To: T10 SAS Protocol Working Group

Subject: SAS 2.+ : 08-249 Link Layer Power Management

This proposal is a complement to 08-015. This proposal focusses on link layer changes to support lower power modes.

Figure 118 — SL (link layer for SAS logical phys) state machines (part 1)

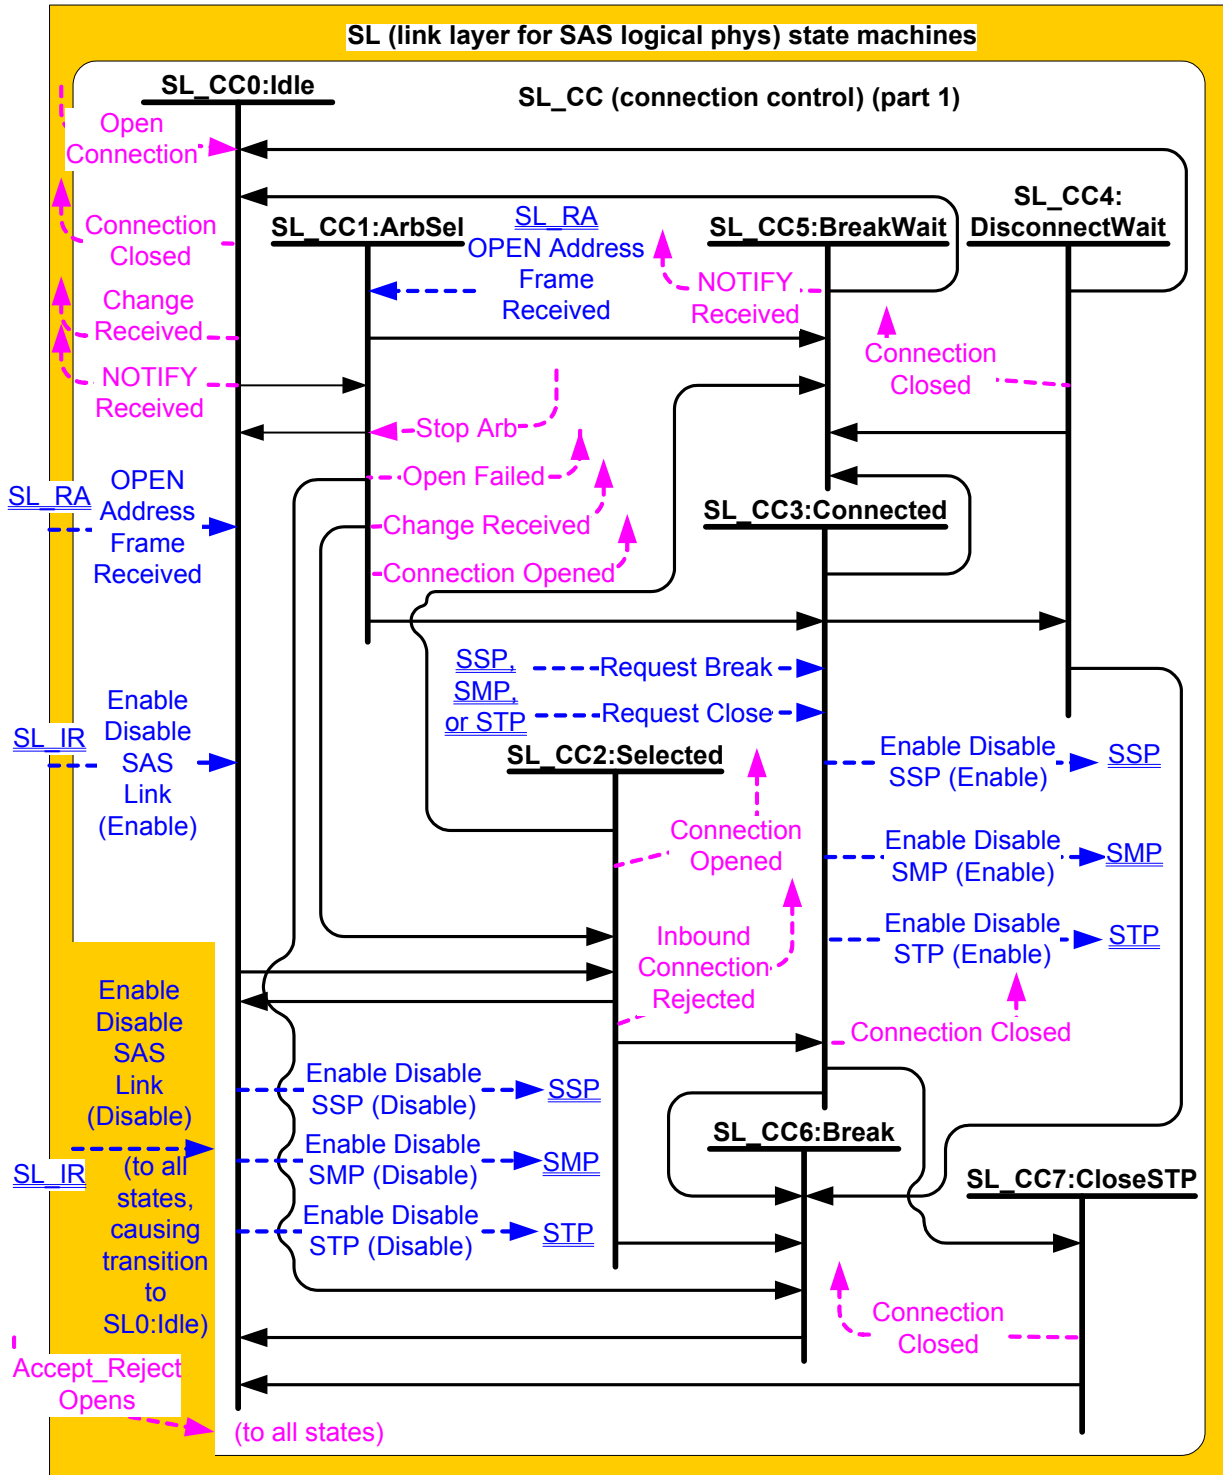
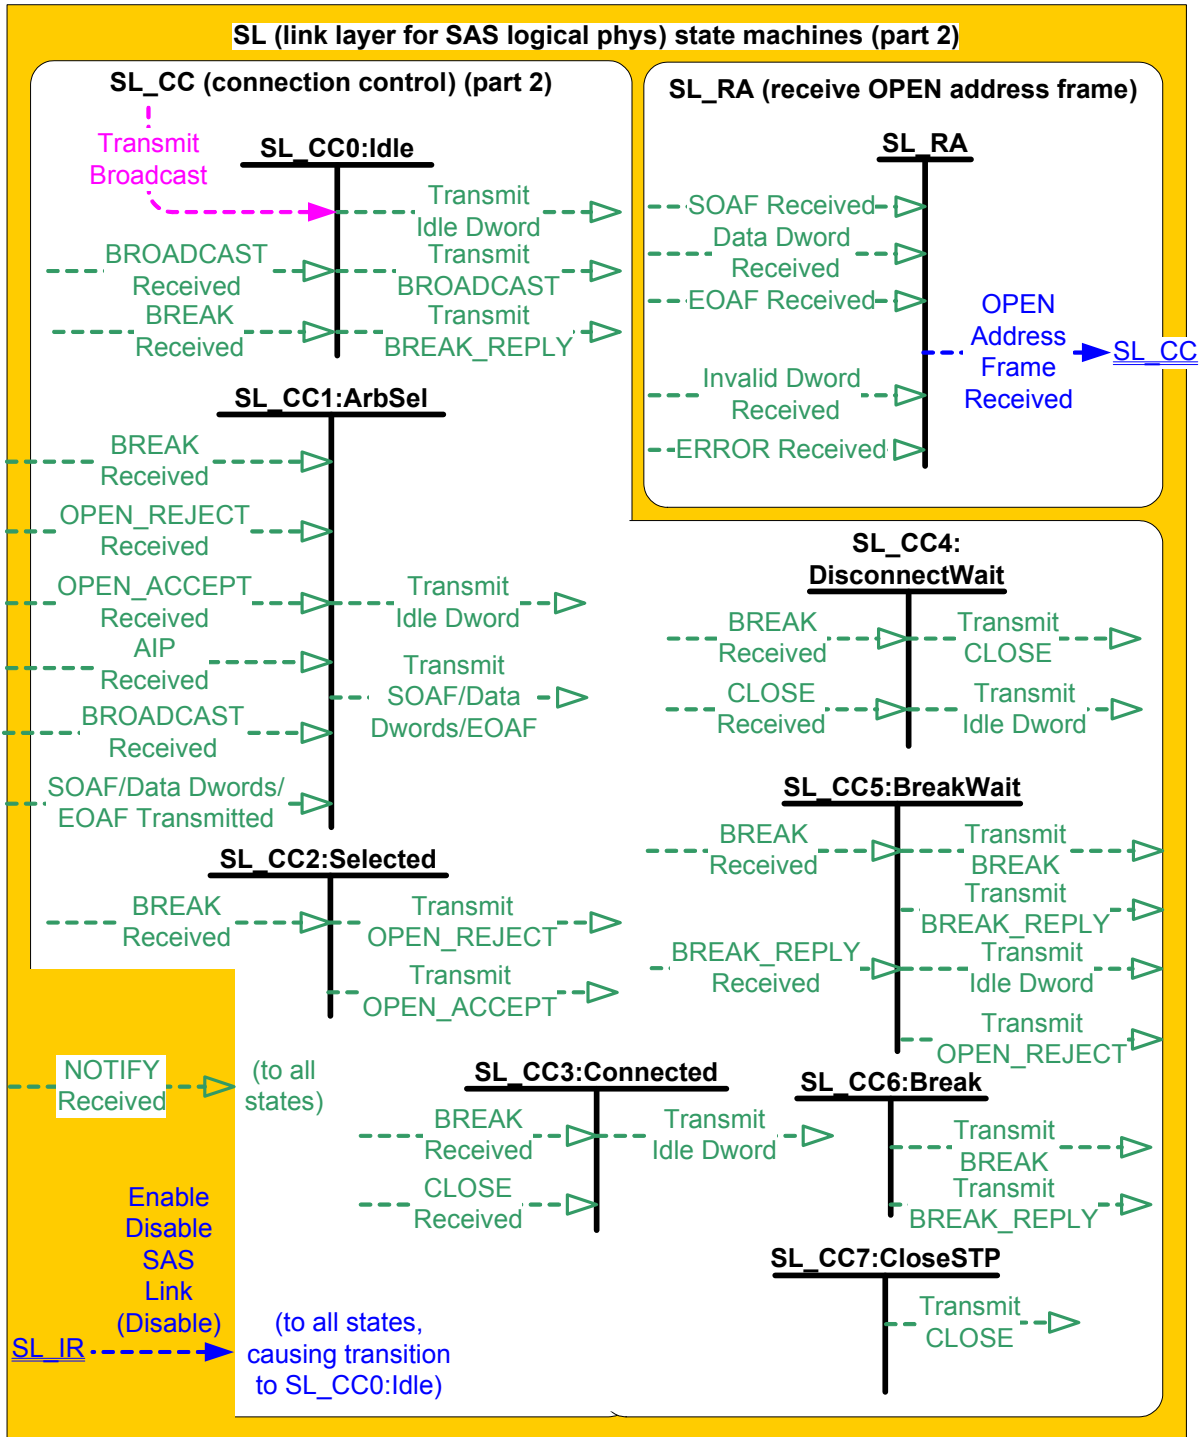
[Editor's Note 0: Need to update figures with new states, and with Request Power Management request coming down, and Phy Power confirmation coming up.](#)

Figure 120 — XL (link layer for expander logical phys) state machine (part 1)

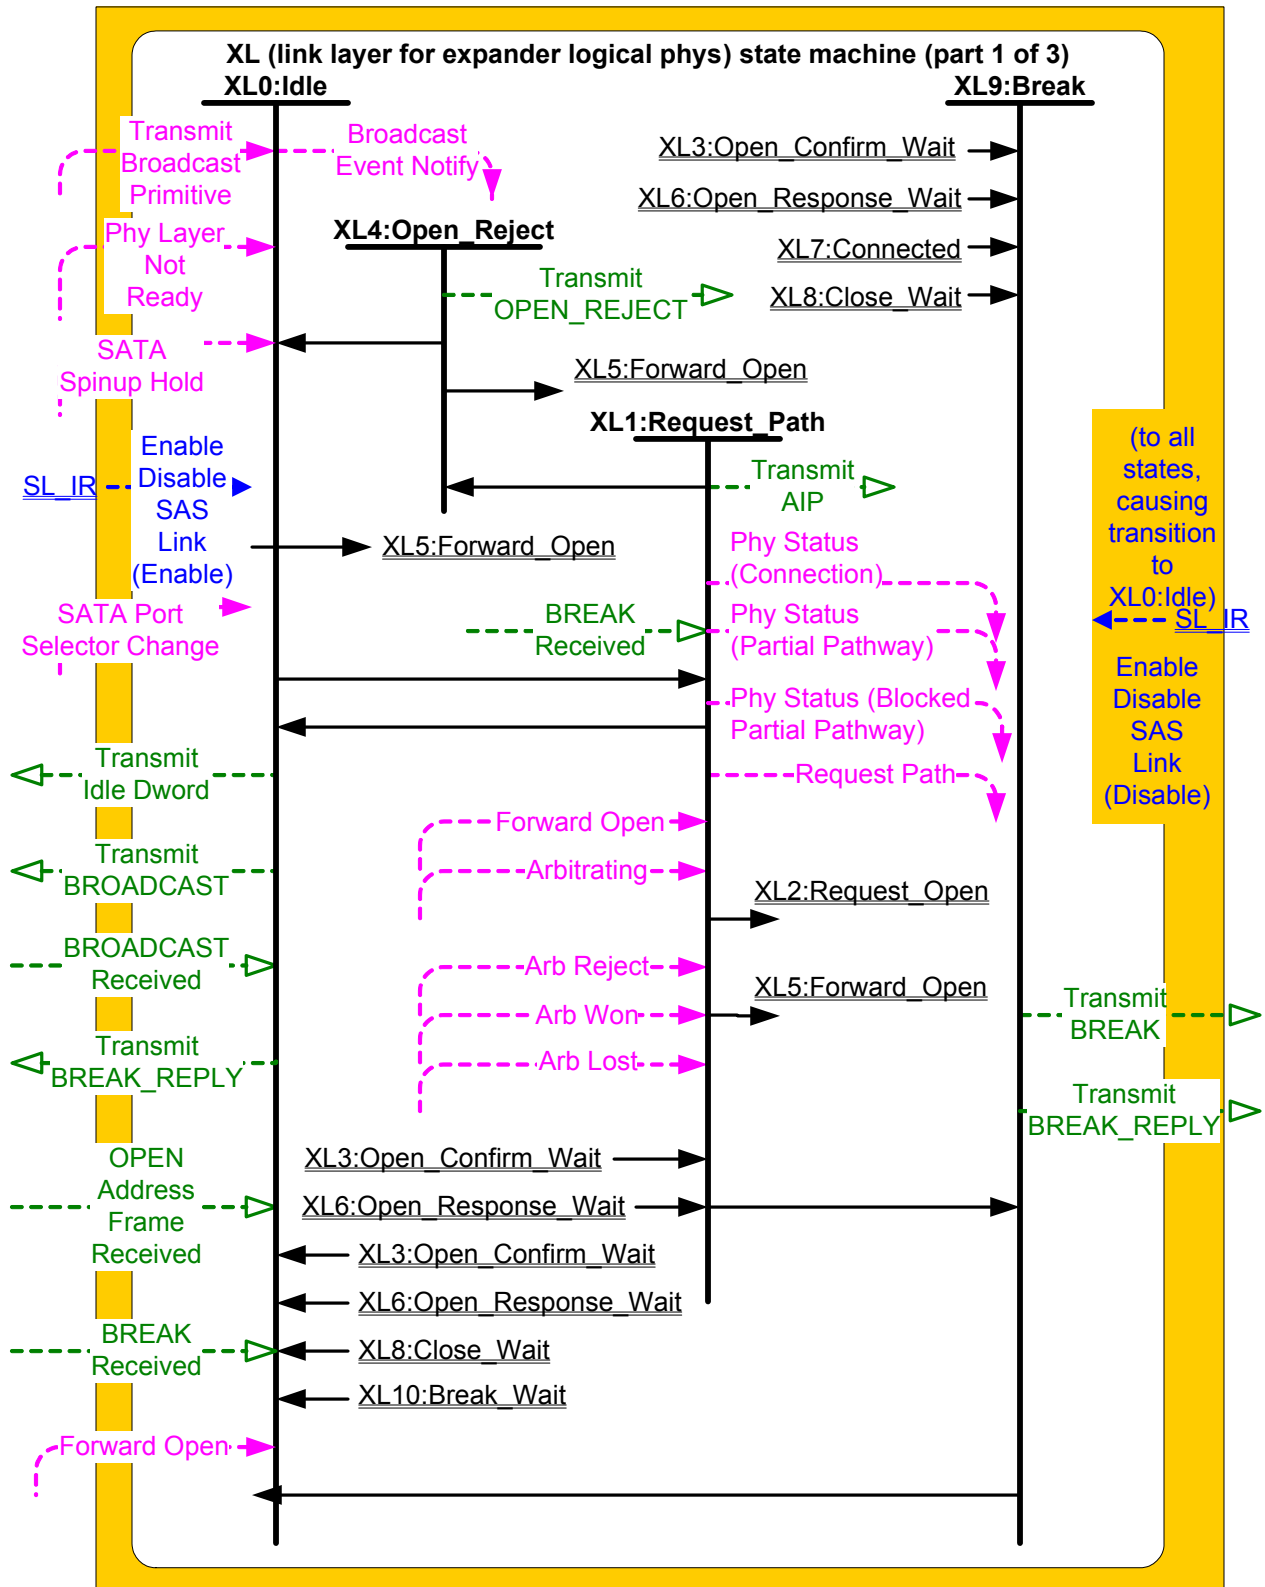
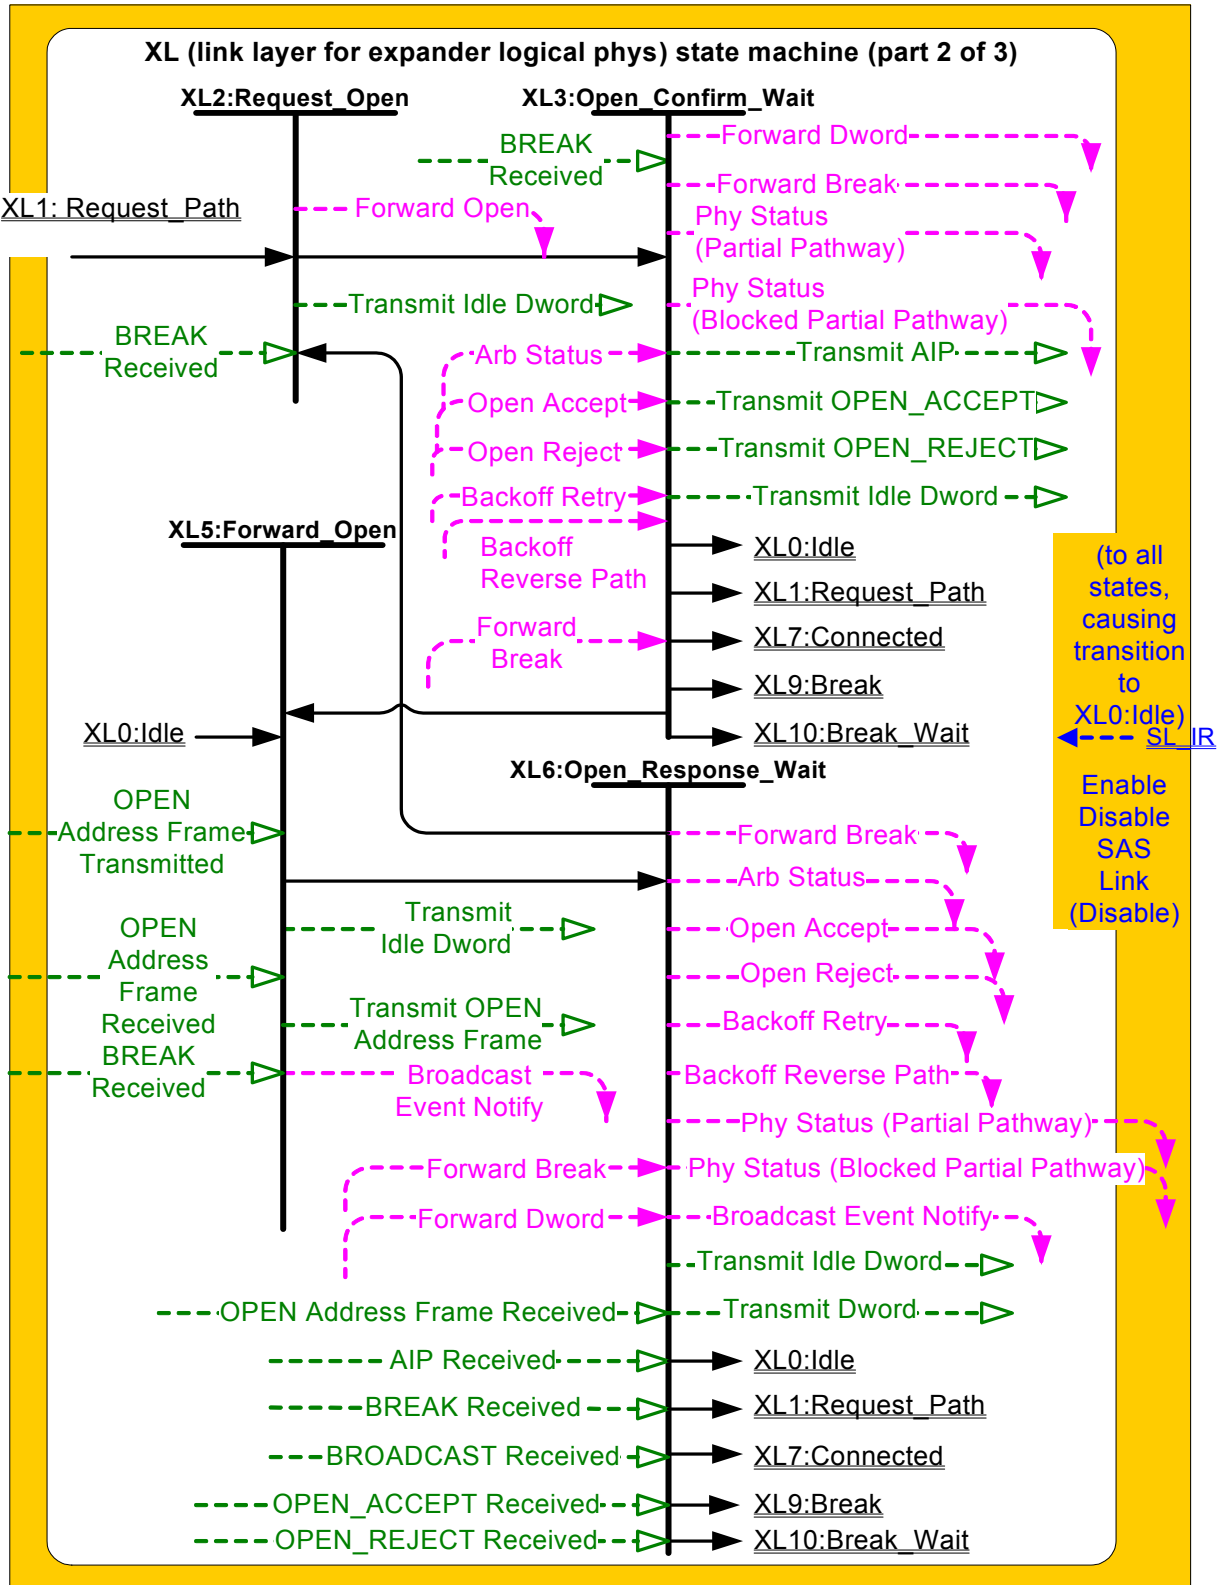
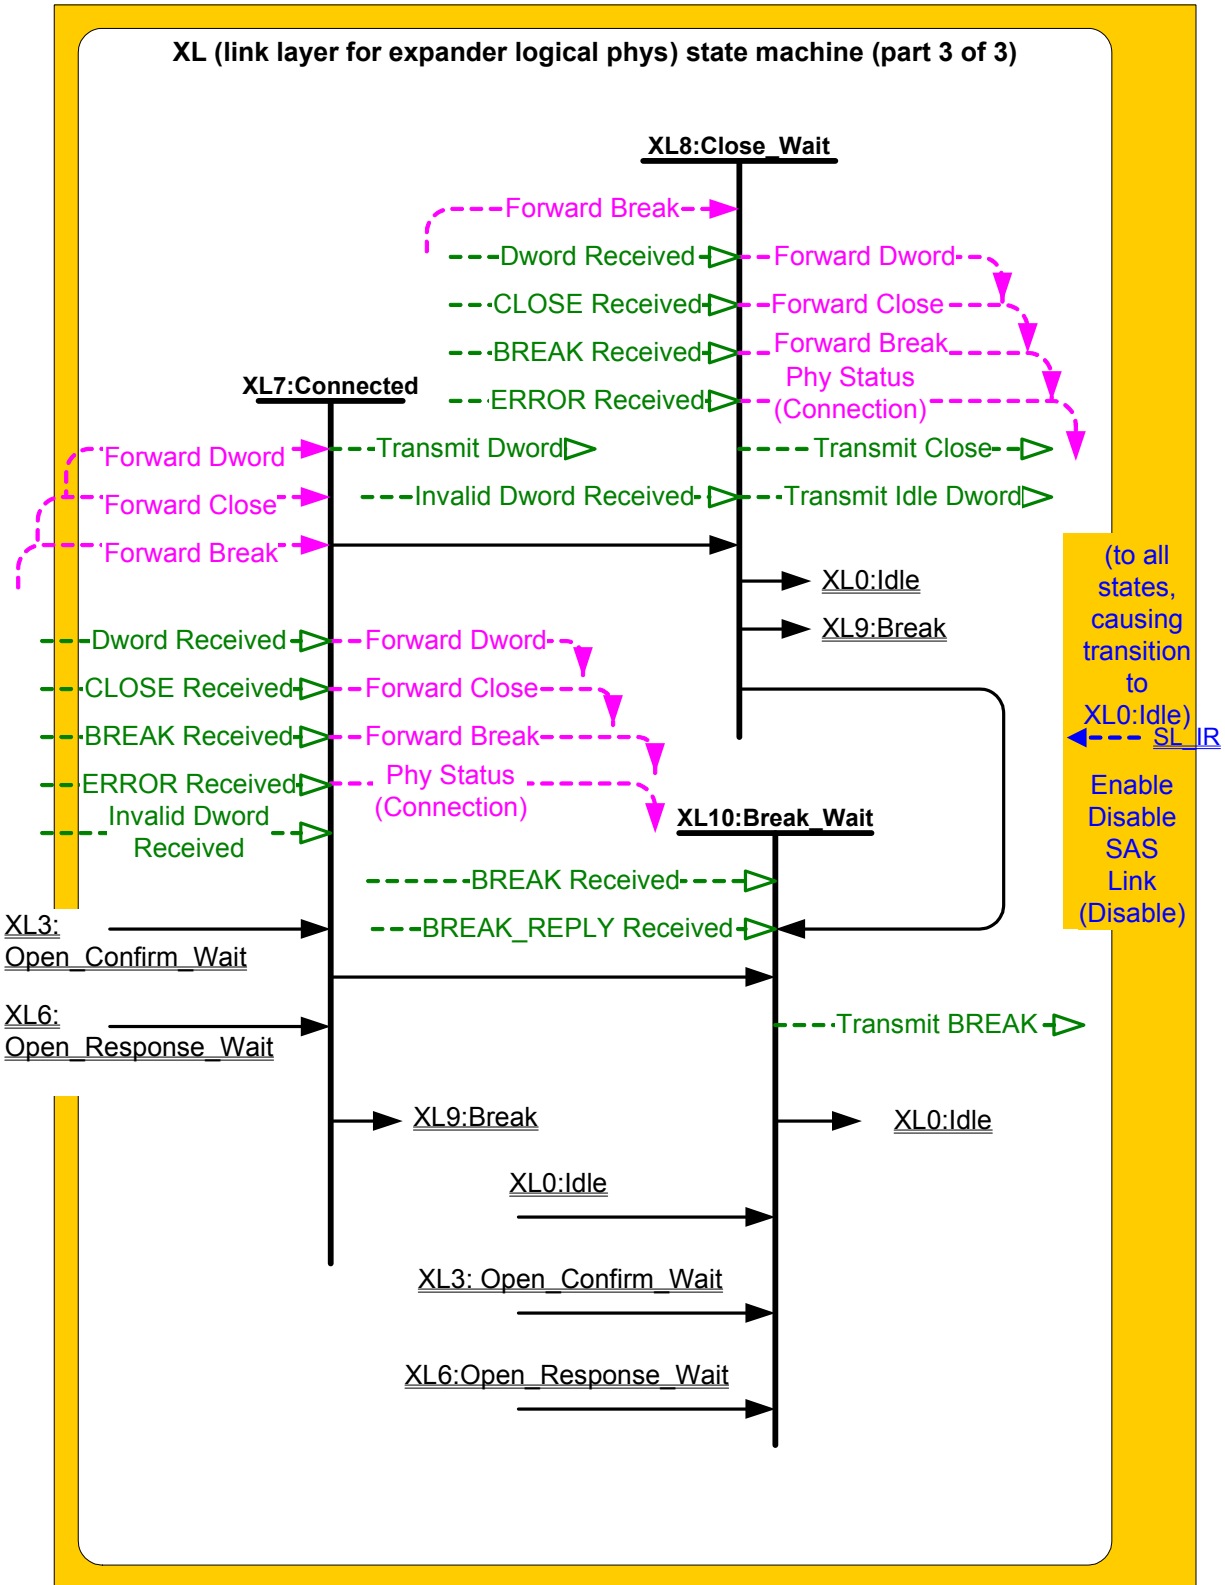
Editor's Note 12: Need to update figures with new states, and with Request Power Management request coming down, and Phy Power confirmation coming up.
